Amendment 39-18008; AD 2014-22-03]

Airworthiness Directives; Various Restricted Category Helicopters

ACTION: Final rule.

2014-22-03 **Various Restricted Category Helicopters**: Amendment 39-18008; Docket No. FAA-2014-0337; Directorate Identifier 2014-SW-029-AD.

Figure 1 to Paragraph (f)

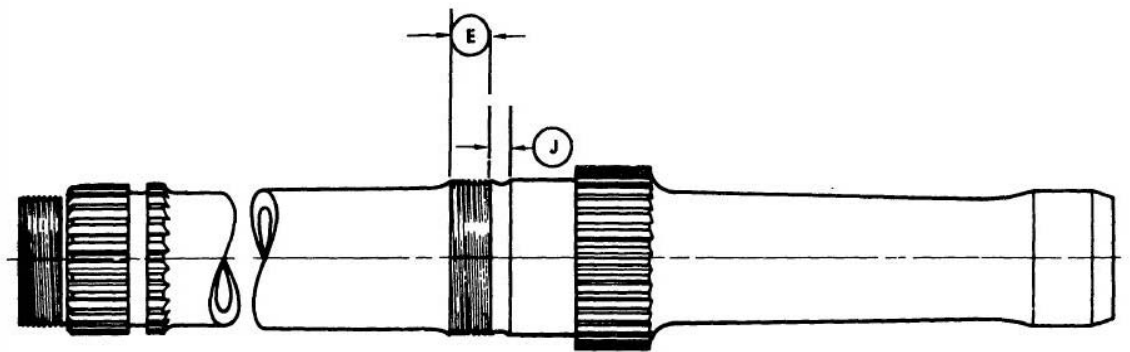
(i) Remove any surface rust with a wire brush or steel wool and, using a 10X or higher power magnifying glass, inspect the areas of the mast as shown in area E and area J of Figure 1 to Paragraph (f) of this AD for pitting, corrosion, or a crack.

(2) If there is a crack, pitting, or corrosion, before further flight, replace the mast with an airworthy mast.
